RE: NATIONAL DISTRIBUTION COMPANY PROJECT NO. 4579.80
(MAP E-17)

RE: ENGINEER'S CERTIFICATION FOR NATIONAL DIST. CO WAREHOUSE (E-17/D34B)
RECEIVED OCTOBER 13, 1993 FOR CERTIFICATE OF OCCUPANCY APPROVAL
STAMPED & DATED 10-12-93.

RE: DRAINAGE REPORT & GRADING PLAN FOR NATIONAL DIST CO WAREHOUSE (E-17/D34B)
RECEIVED DECEMBER 30, 1992 FOR BUILDING PERMIT APPROVAL
STAMPED & DATED 12-28-92

RE: NATIONAL DISTRIBUTING COMPANY - PHASE 2 (E17-D34B). GRADING AND DRAINAGE PLAN FOR SITE DEVELOPMENT PLAN FOR BUILDING PERMIT, AND FOR BUILDING APPROVALS. ENGINEER'S STAMP DATED MARCH 31, 2000.

8" X 18" WEIR @ POND A-1

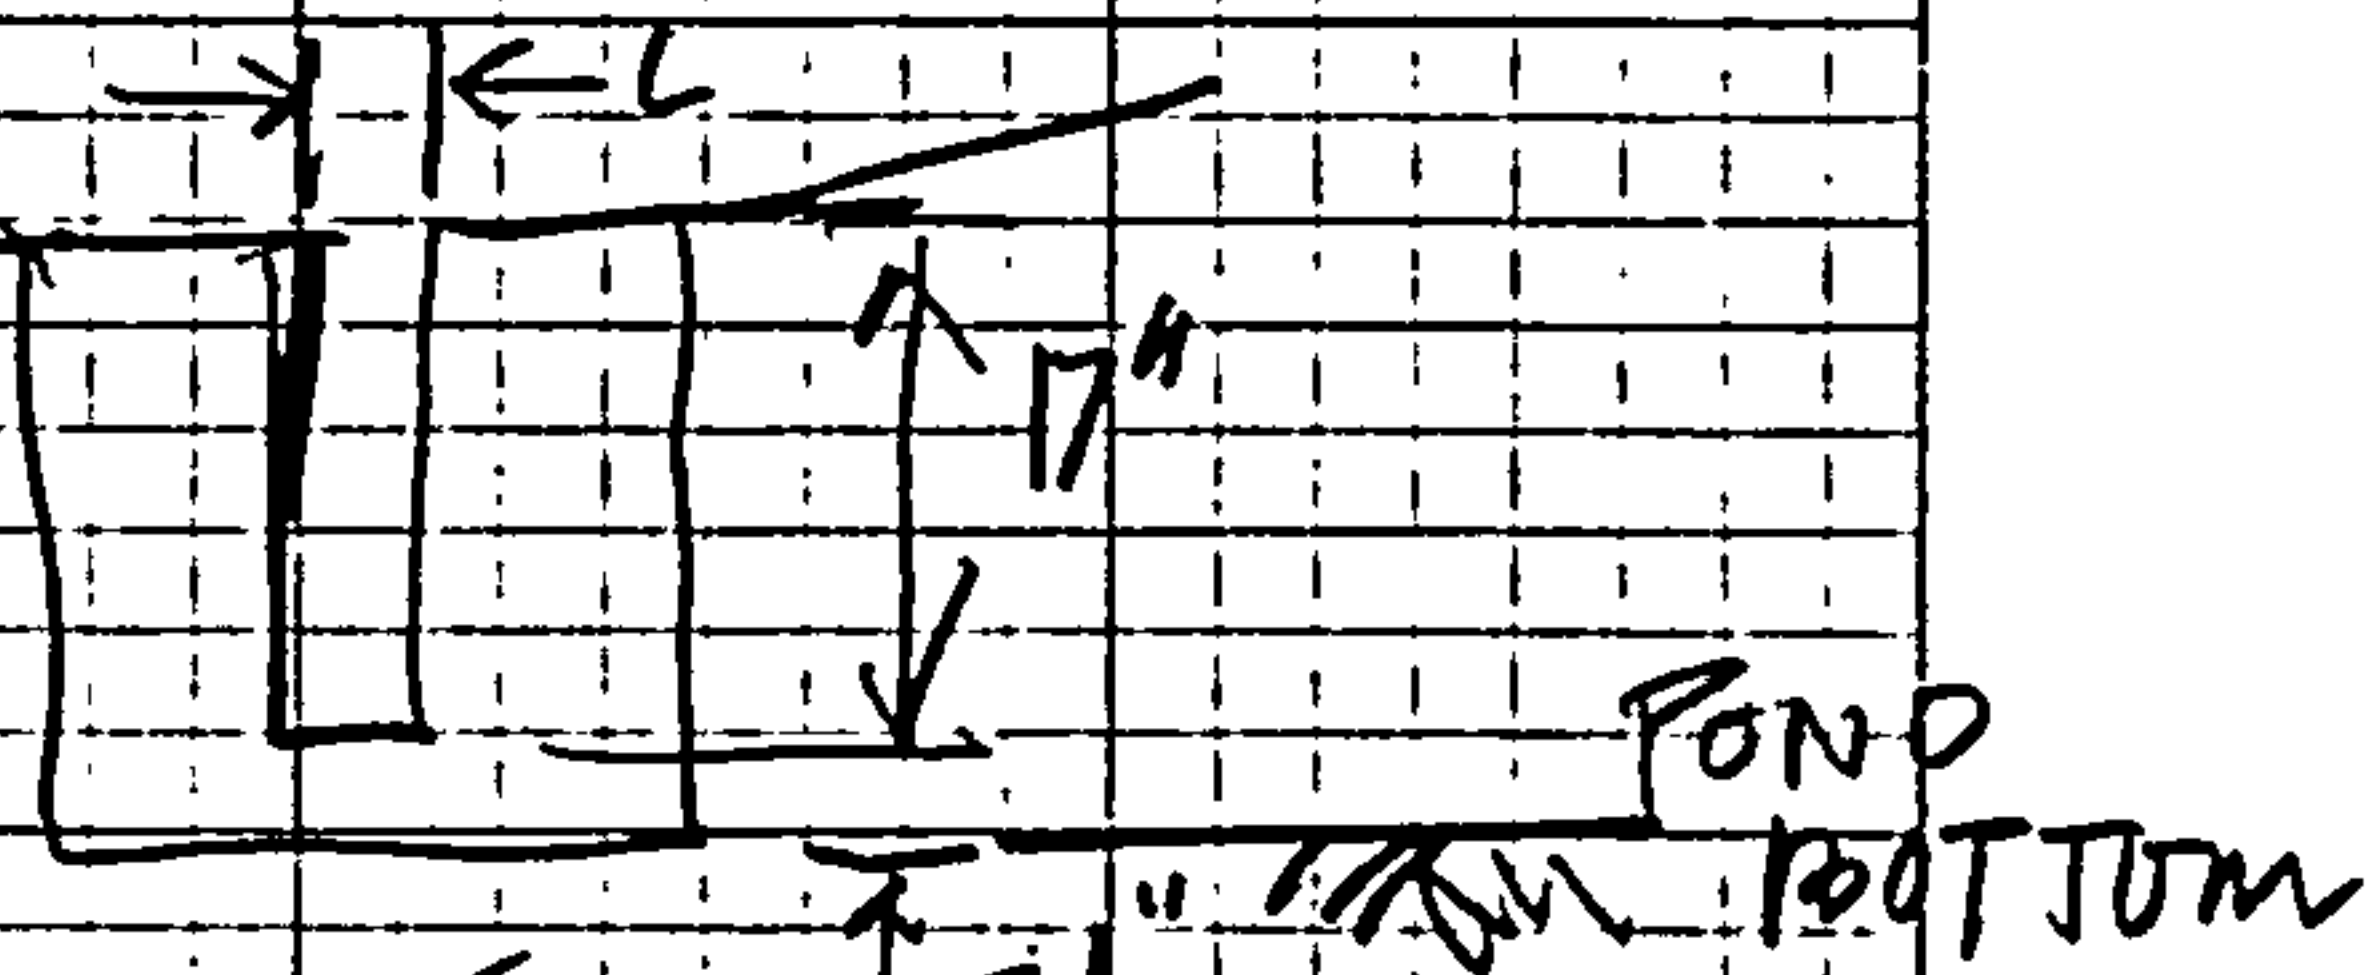
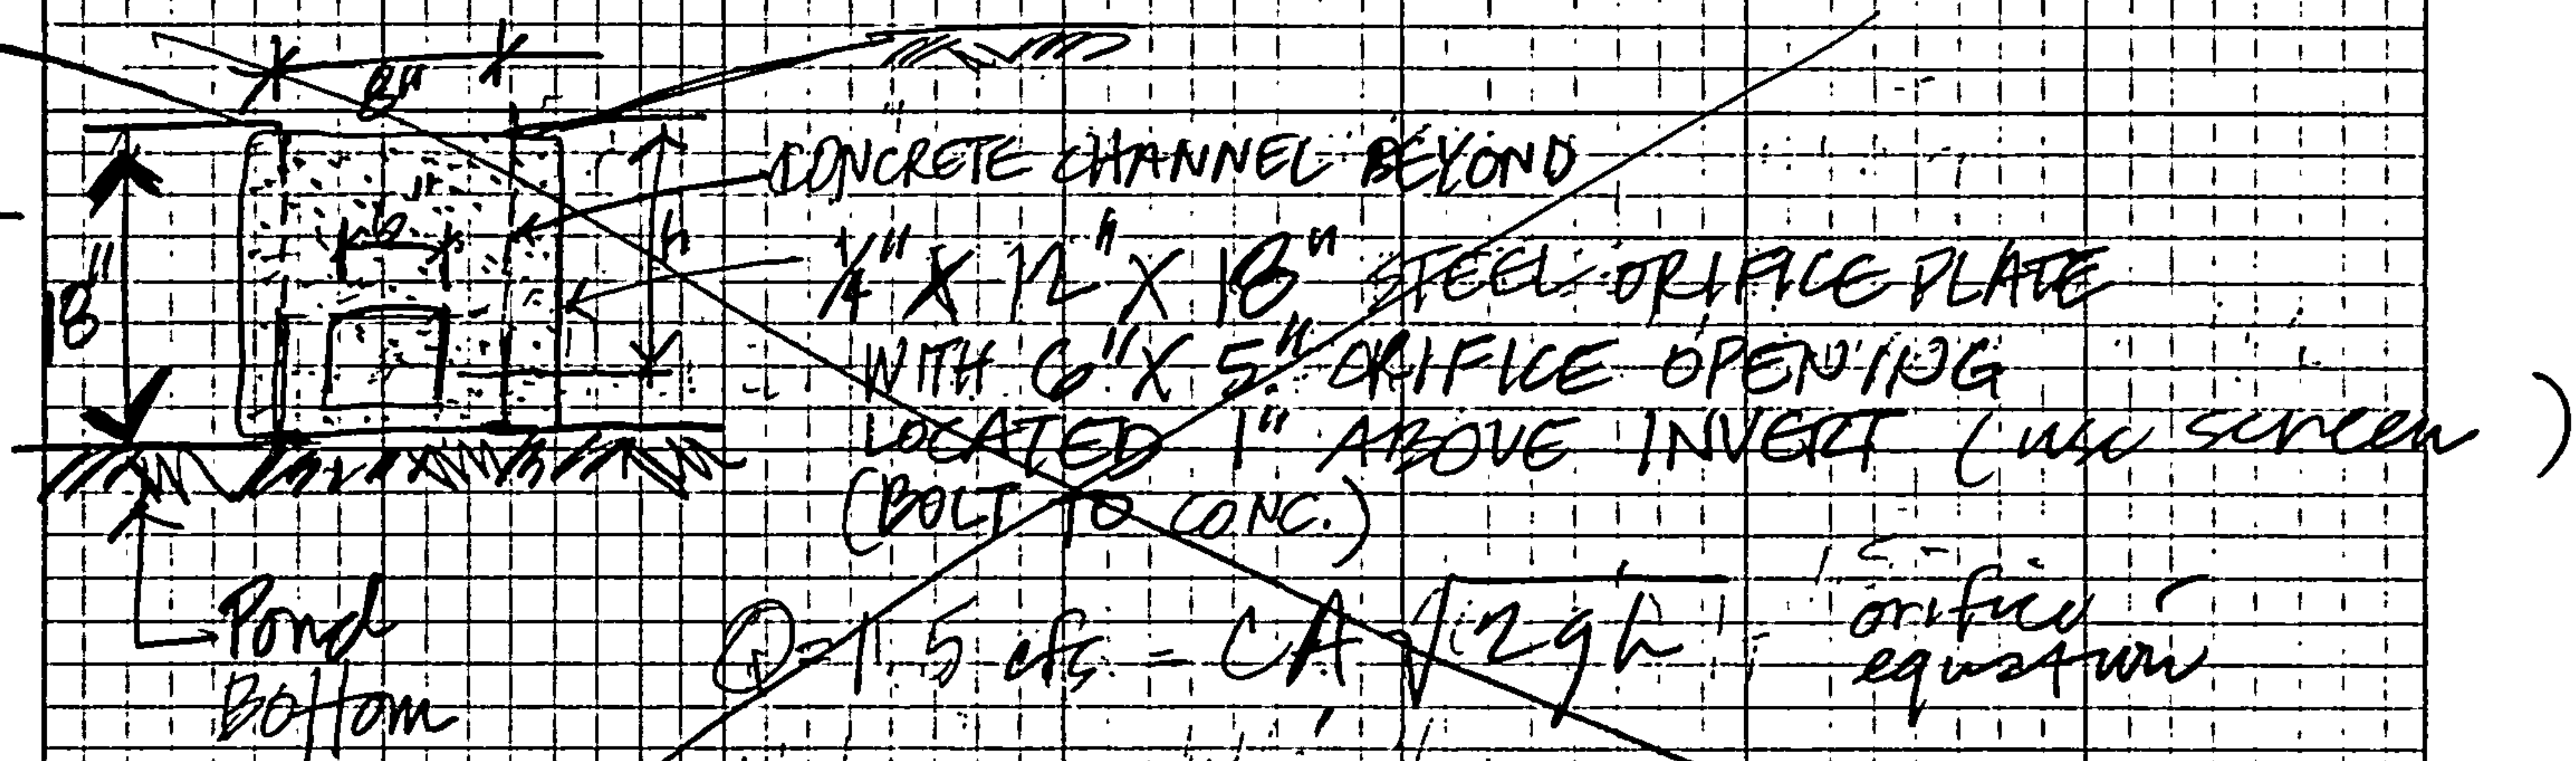
$$Q = (3) (0.67) (1.5)^{3/2} = 3.7 \text{ cfs N.G. redesign!}$$

DO NOT USE

design for $Q = 1.5 \text{ cfs}$

$$Q = 3 (L) 1.4^{1.5} = 1.5 \text{ cfs}$$

$$L = 0.302' = 3.6" \text{ OK use this w/ screen}$$

WEIR on Pond A-2

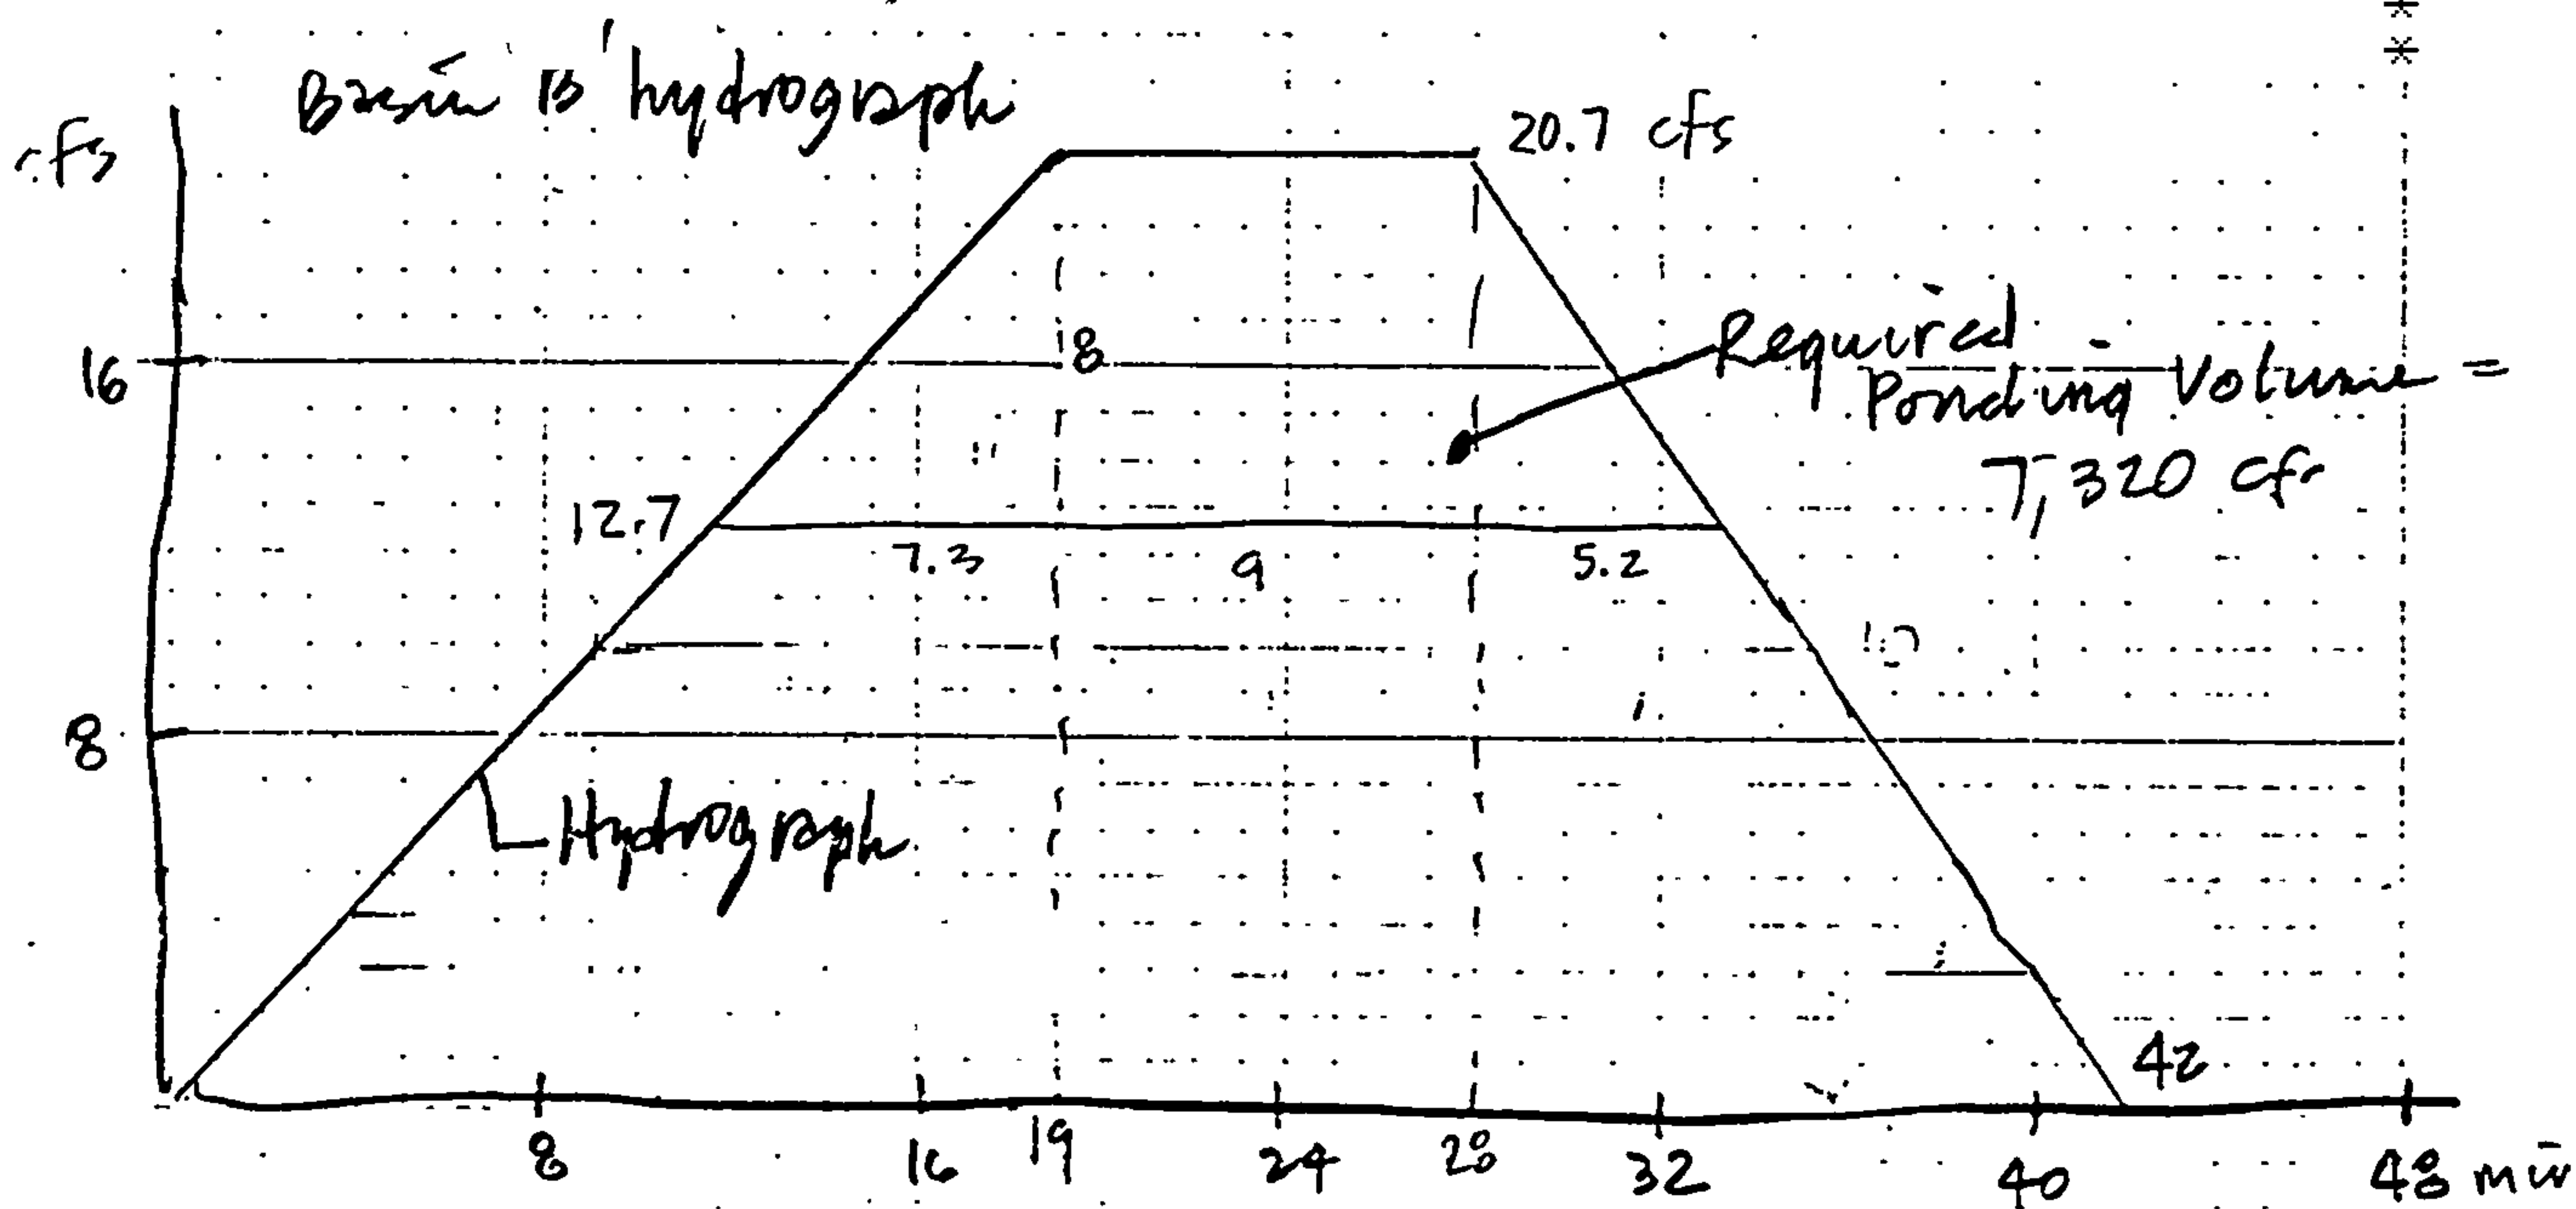
$$Q = 2.3 \text{ cfs} \quad \text{N.G. redesign}$$

$$Q = 7.5 \text{ cfs} = 3(L)(8/12)^{1.5}$$

$$L = 4.6' \quad \text{OK use this}$$
